JP-4 SERVICE NOTES

Second Edition

INFORMATION ON DESIGN CHANGES

MODULE BOARD 181-020C (Etch mask 052-314C)

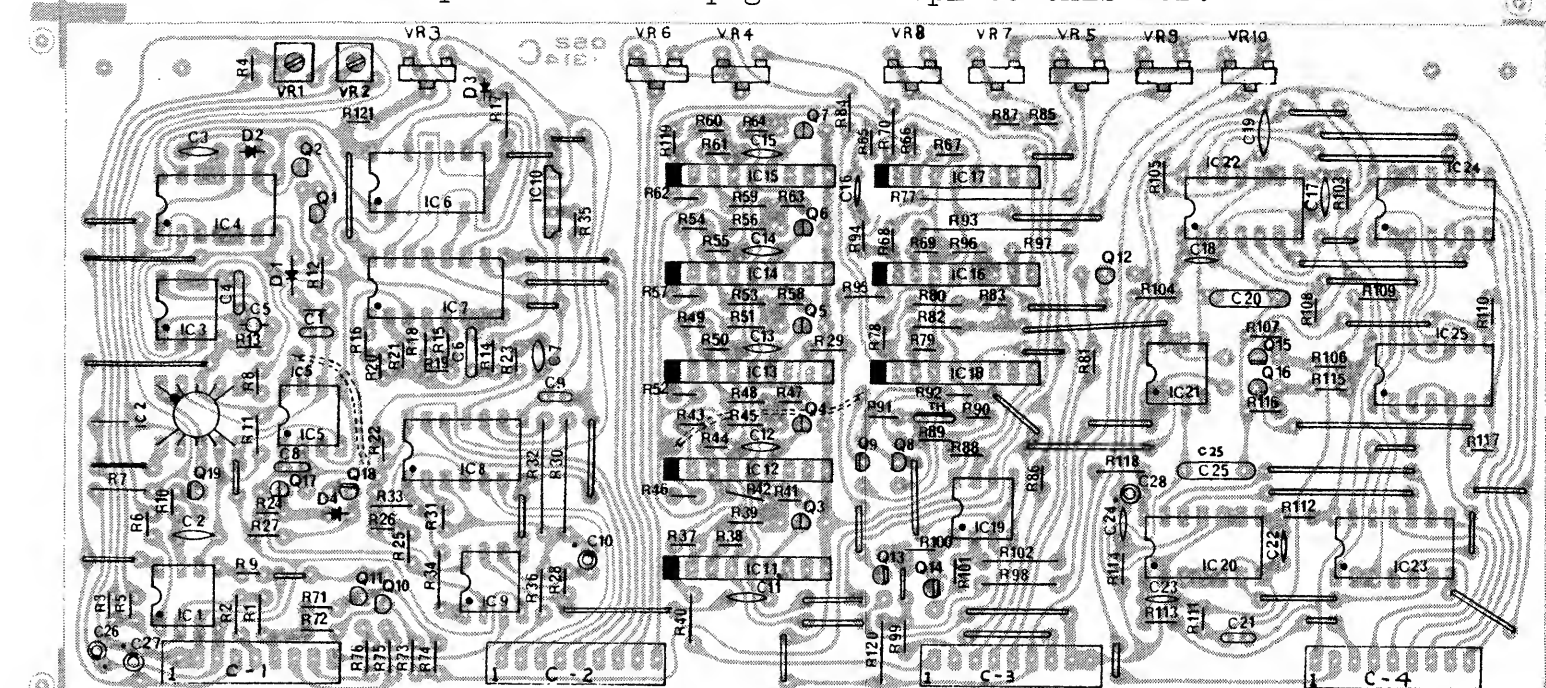
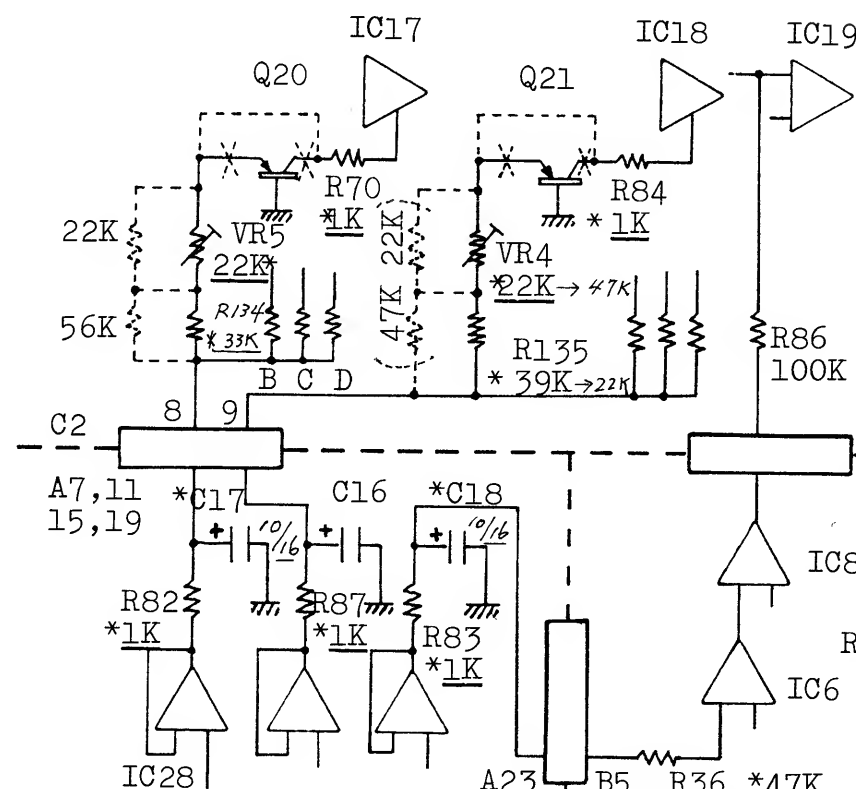
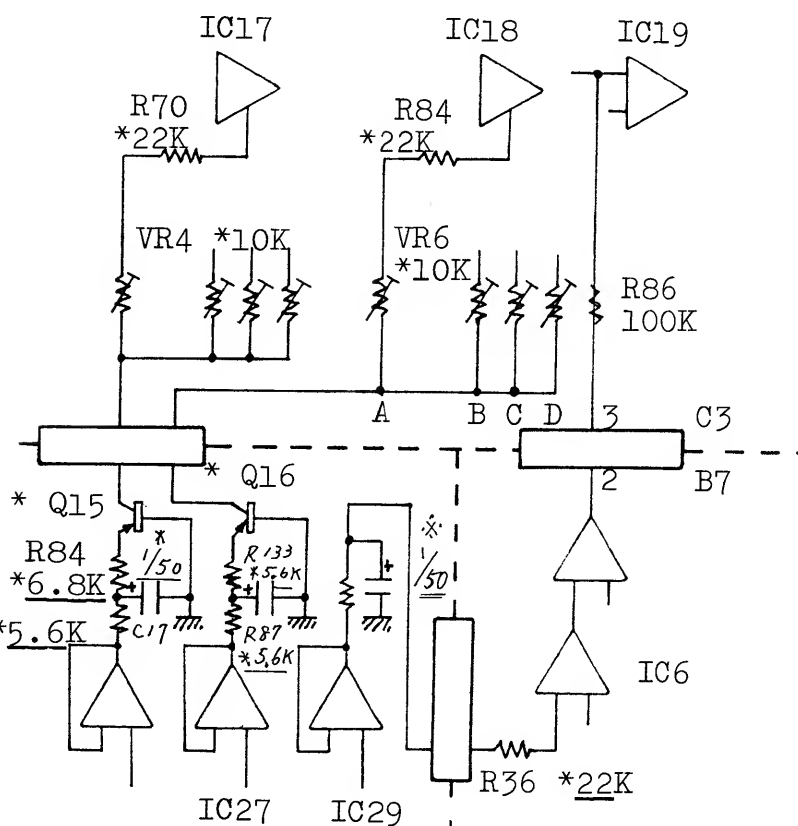
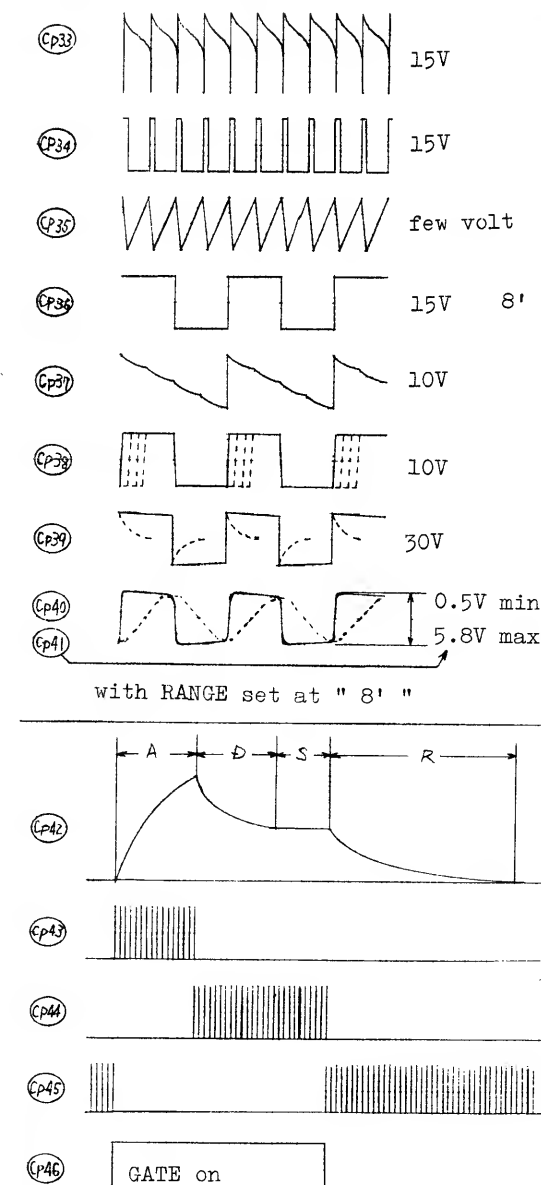
The VCF circuit on the Module Board has been changed for easier RESONANCE adjustment and this change affects the Mother and Module Controller boards. Simplified circuits shown below illustrate the differences between the new and the old configurations.

Replacement will be a new one, it requires some modifications on itself when it replaces old one. Or it requires other PCBs to be modified when new "VCF" is needed.

Just change R36 in value.

SUPPLEMENT on 181-020D Diagram

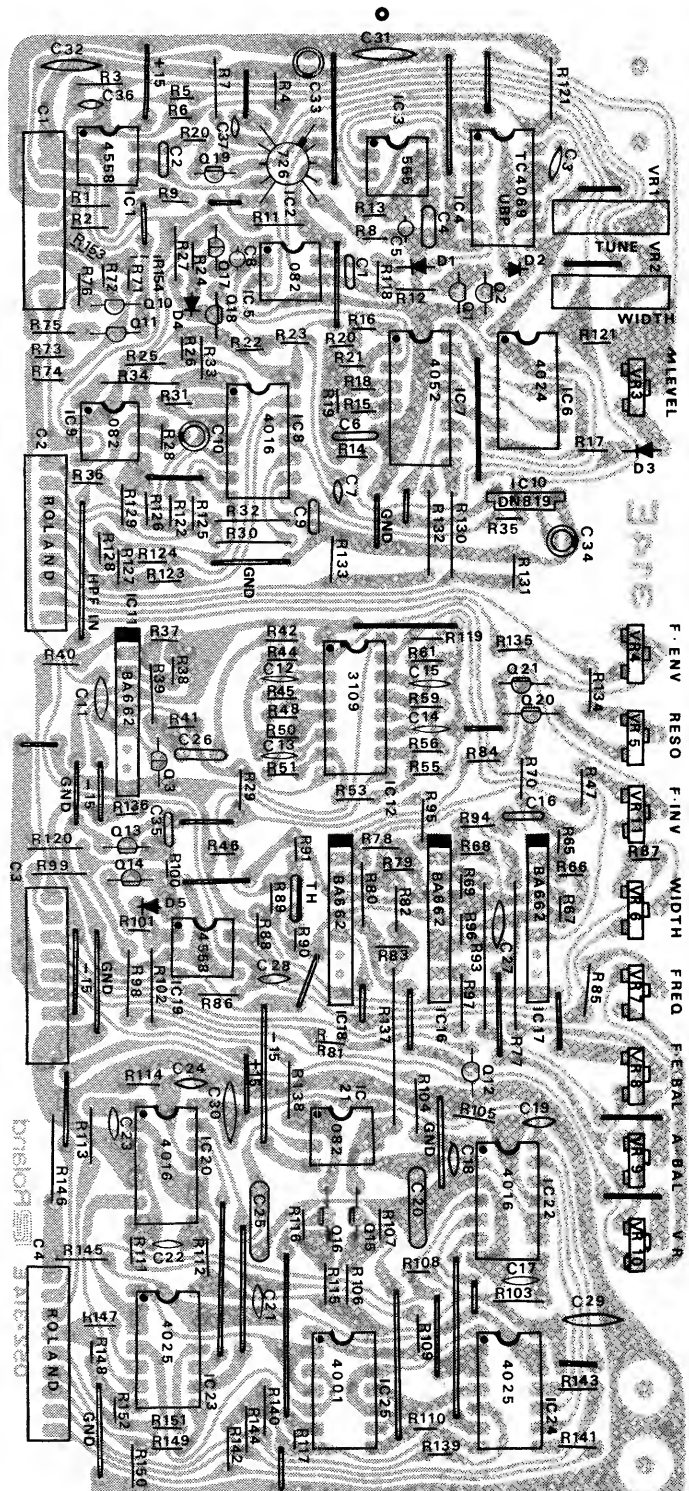
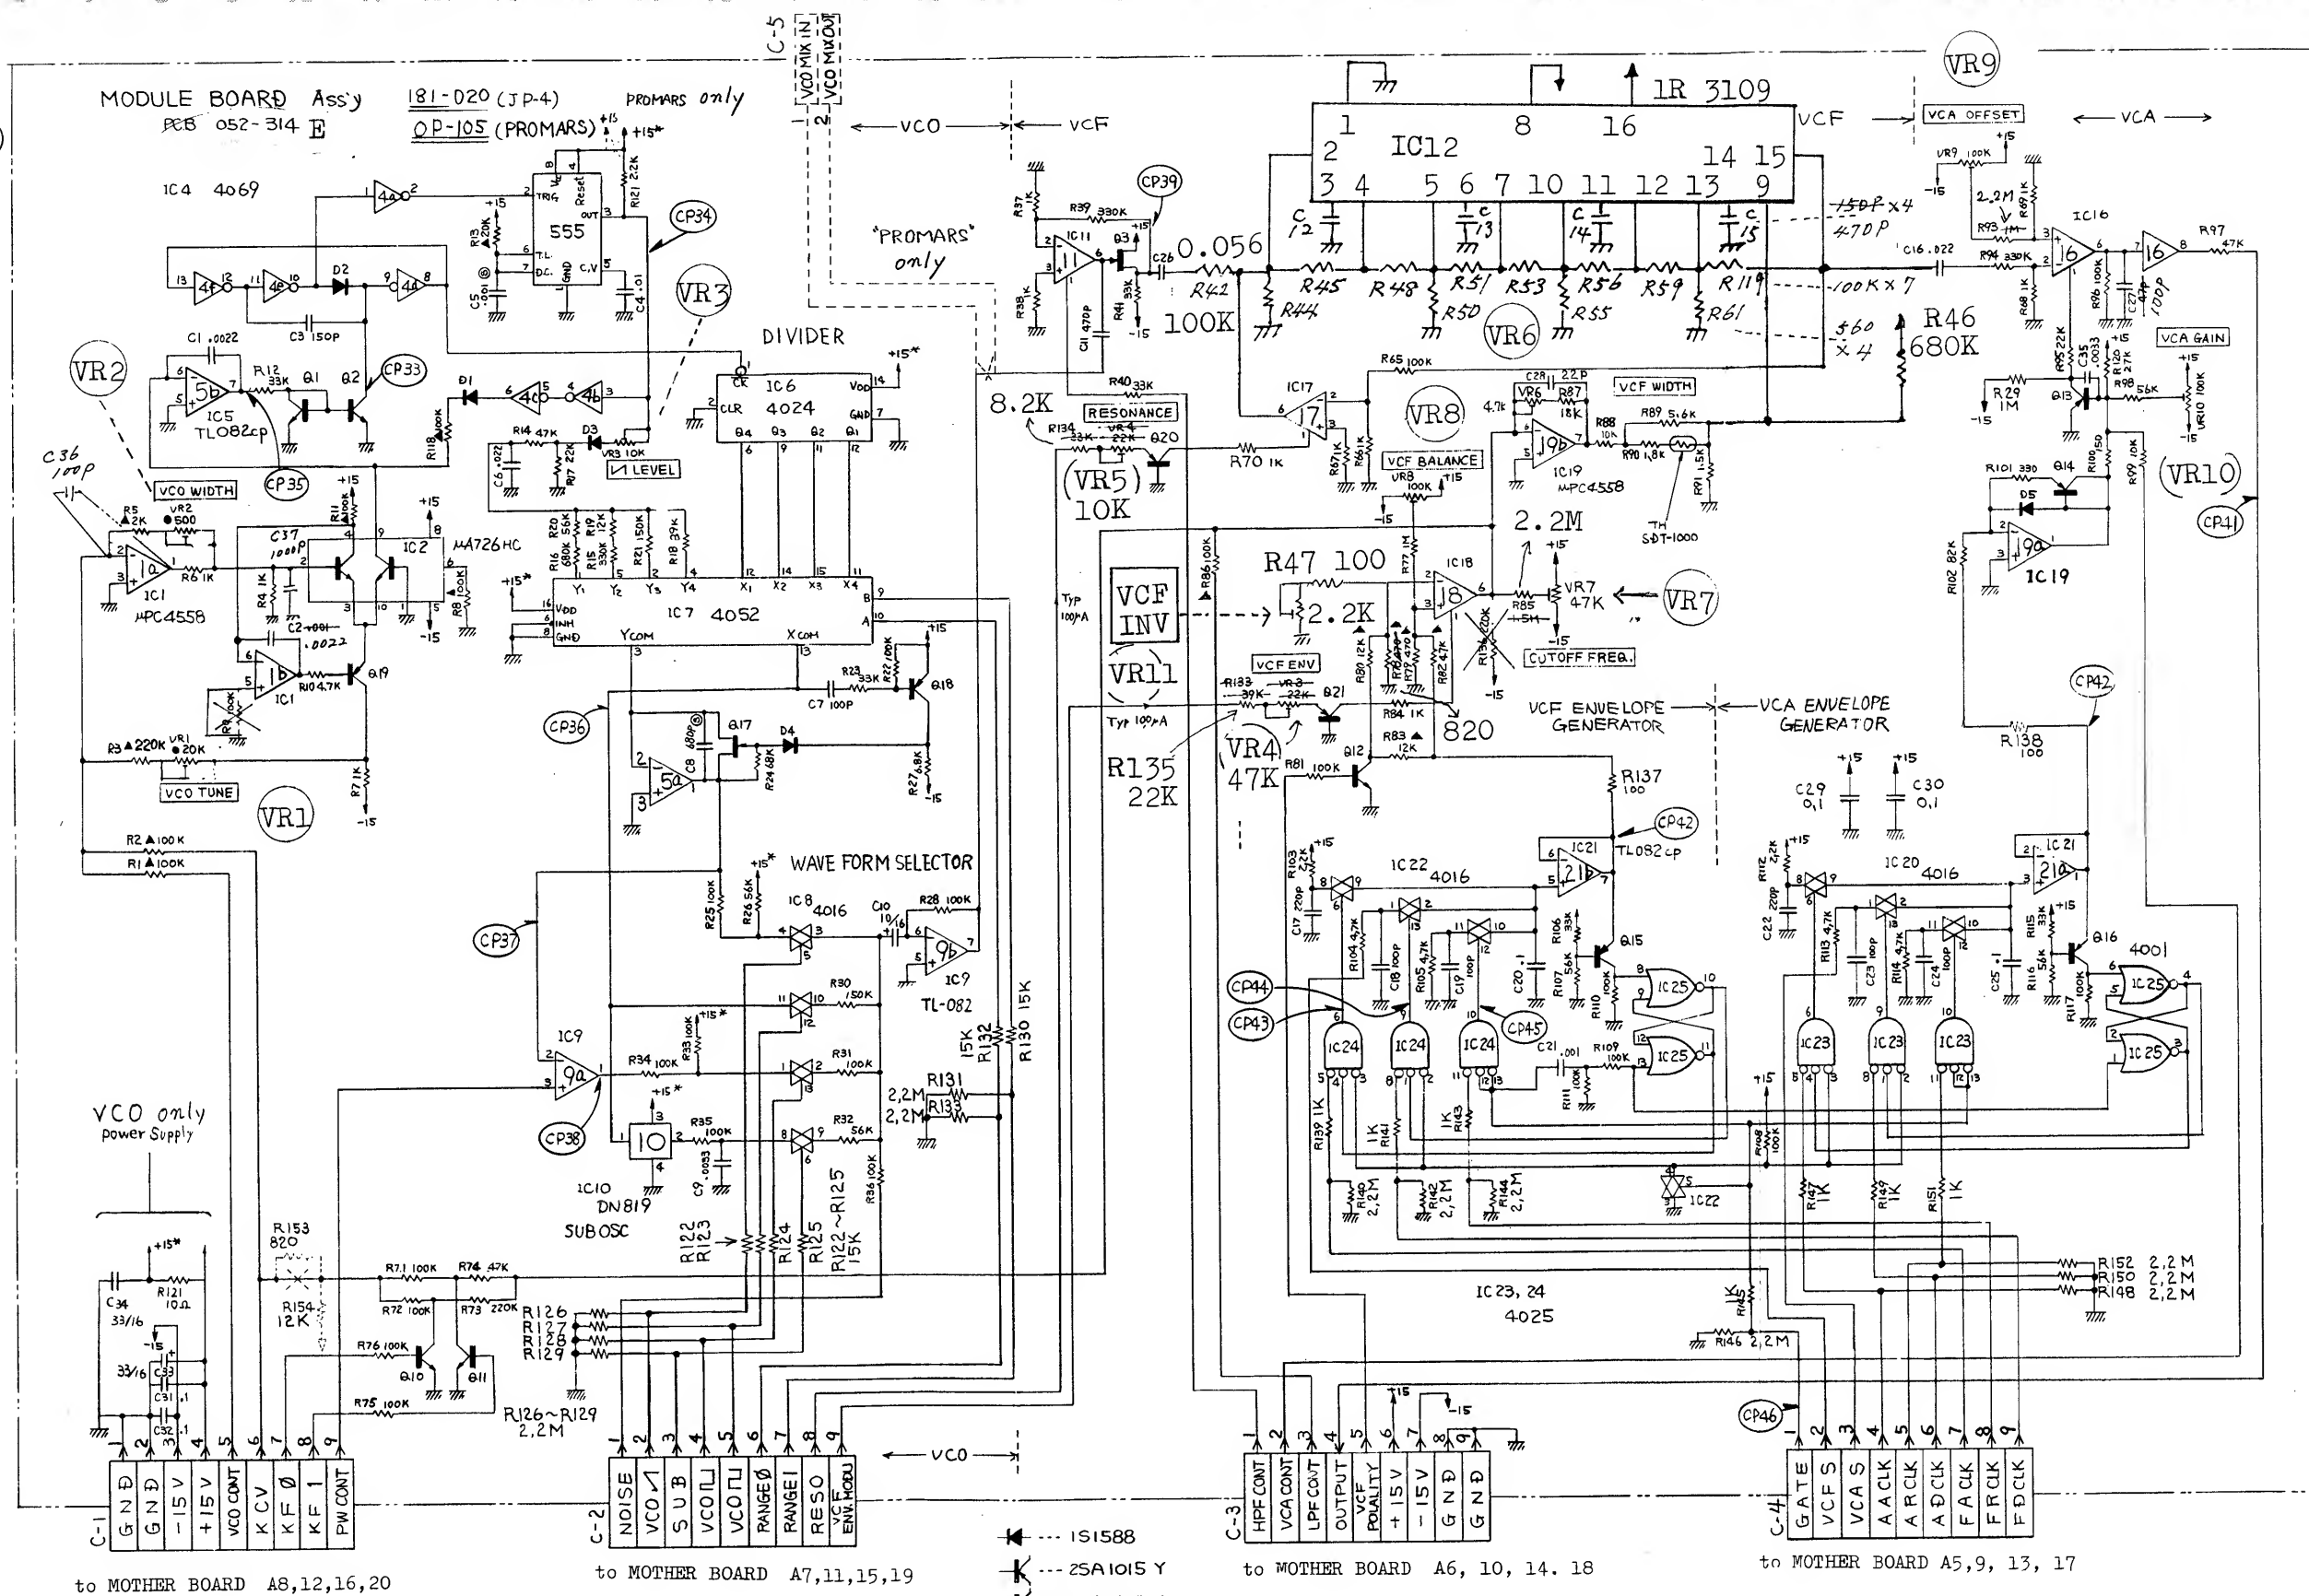
CHANGINGS of VCF IC to 1R3109(IC12) involves some modifications on peripheral circuits whose designations are shown in type-written.

C36 and C37
S/N 861500-
Filter out
pulses induced
on KCV IN

MODULE CONTROLLER BOARD 181-021D/E (Etch mask 052-235D/E) S/N 912200 and above

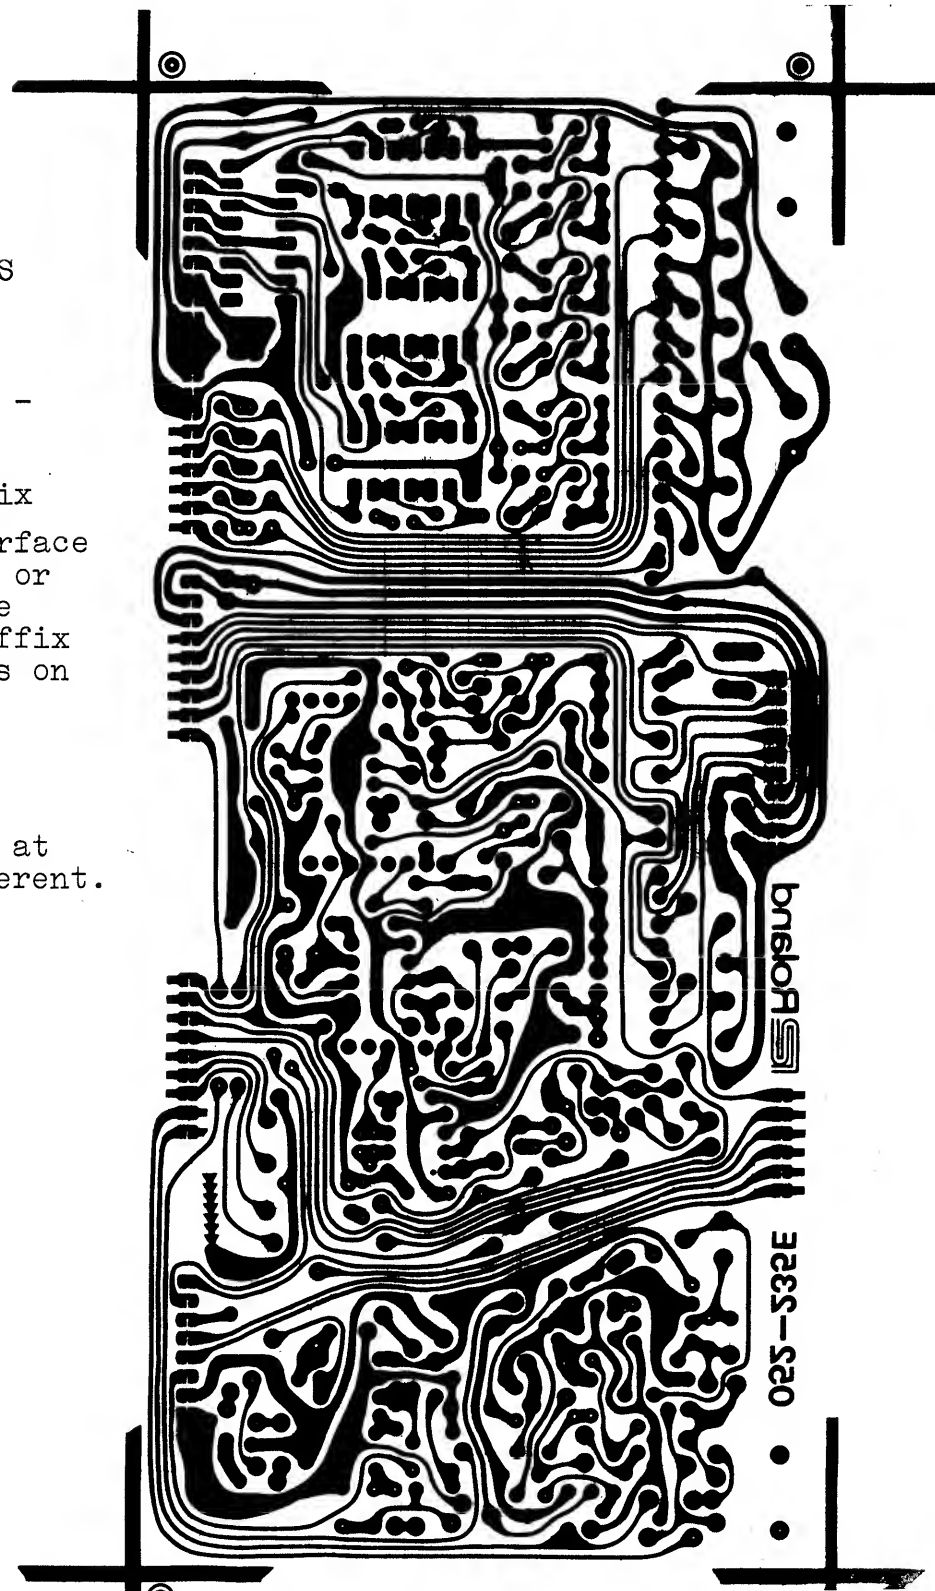
NOTE:
R36 = 47K when associate Module Boards are 052-314D
R36 = 22K when the Module Boards are 052-314C
Refer to "Improvements on MODULE BOARD" on page 19.

KEY ASSIGNER 181-022C (pcb 052-032C)

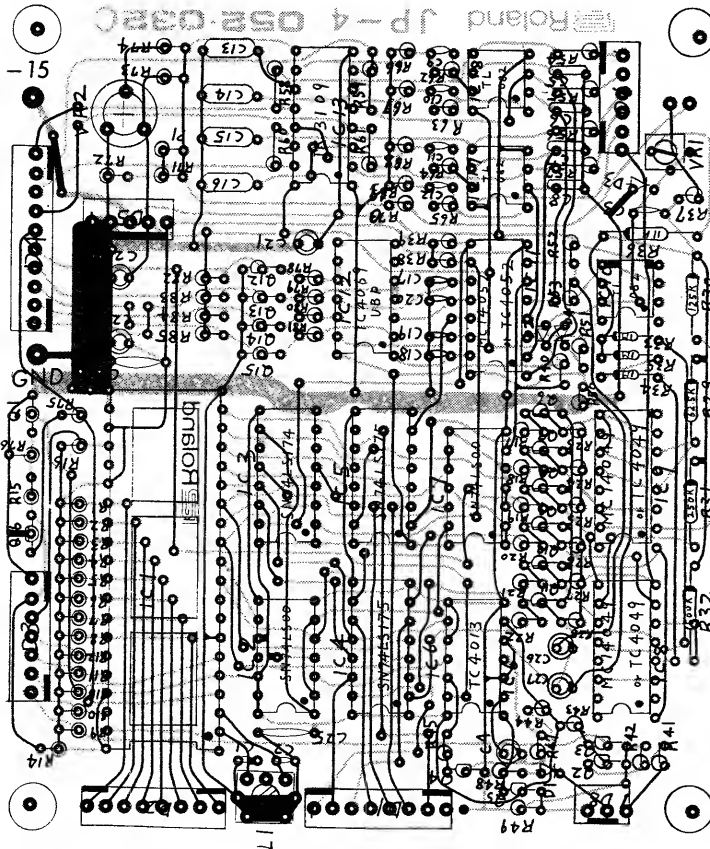
INTERCHANGEABLE
With PORTAMENTO (VR-3)
on CONTROL BOARD D
changed as PCBs change:181-022B--VM10RB10C
K20 2MA181-022C--VM10RB10C
K20 50KB

IMPORTANT! Replacement of 052-032 A or B with C necessitates change of VR3 2MA on Control Board D to 50KB to retain the time constant by compensating for difference between circuit configurations. See p. 12-2.

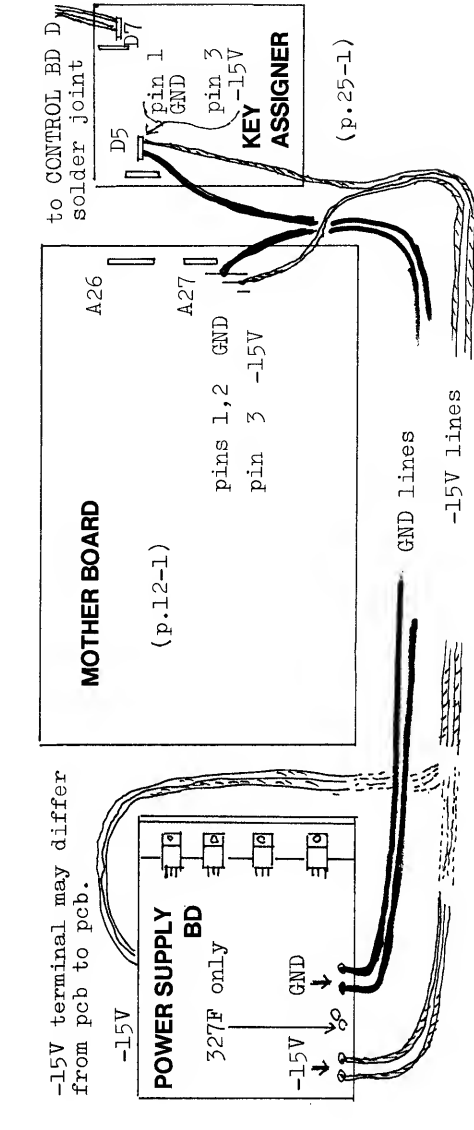
Plugs and receptacles on D7 (Key Assigner) and J-4 (Control Board D)
are solder jointed, or leads are directly soldered on conductive
foils at terminal areas. This treatment also eliminates impedient
Portamento effects in PORTAMENTO OFF mode.
